## **Addendum 47: Regulation No. 48**

### **Revision 6 – Amendment 4**

Supplement 6 to the 04 series of amendments - Date of entry into force: 30 January 2011

### **Uniform provisions concerning the approval of vehicles with regard to the installation of lighting and light-signalling devices**

"Figure 1a  
**Rear**

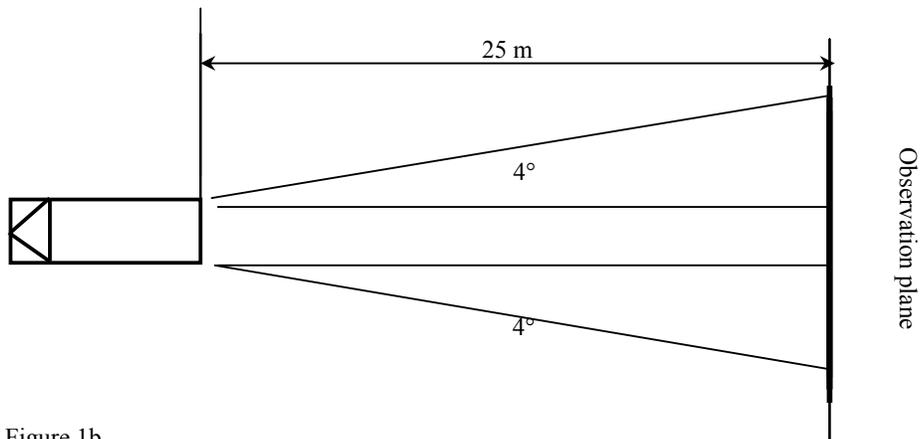
Annex 11, amend the figures to read:
